ADDENDUM NO. 2

Date: May 19, 2025
Project Name: ABP Fire Suppression Improvements
Owner: Little Rock Municipal Airport Commission
Owner Project No.: 231000
Garver Project No. 21A10111

DRAWING NUMBER
EP-602

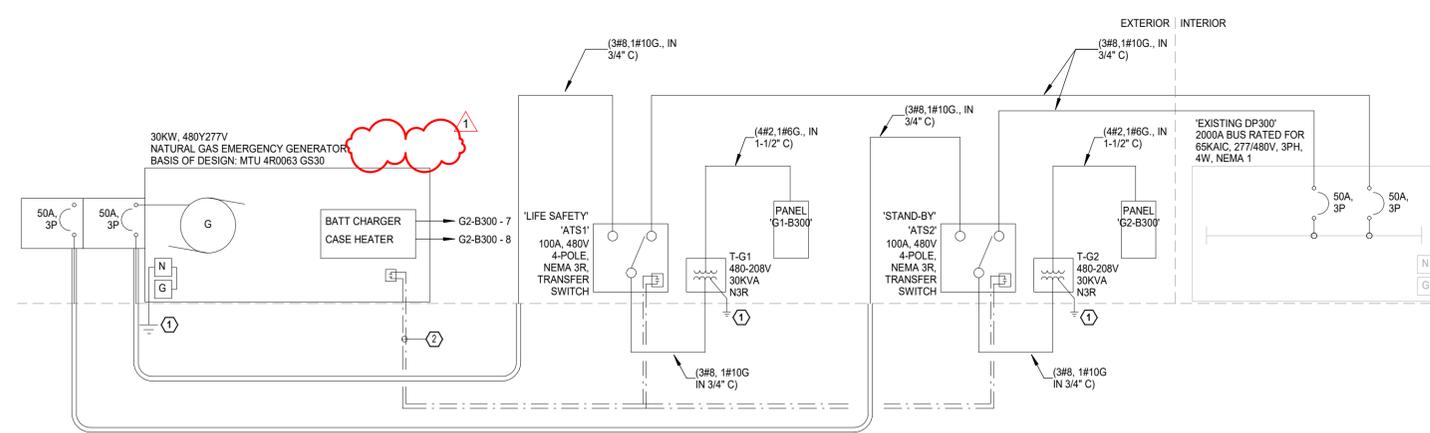
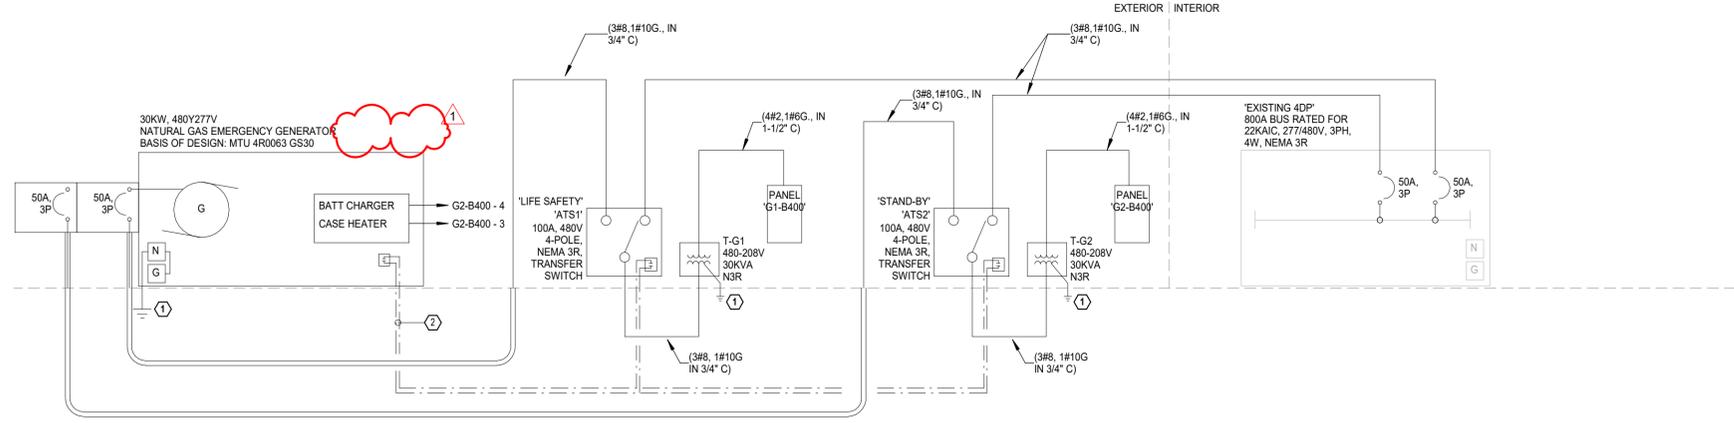
1. Electrical
 - a. Refer to Sheet EP-602 – Electrical One-Line Diagrams – Buildings 200 & 300, dated 5/16/25.
 - i. Remove load bank from generator.
 - b. Refer to Sheet EP-603 – Electrical One-Line Diagrams – Buildings 400 & 500, dated 5/16/25.
 - i. Remove load bank from generator.
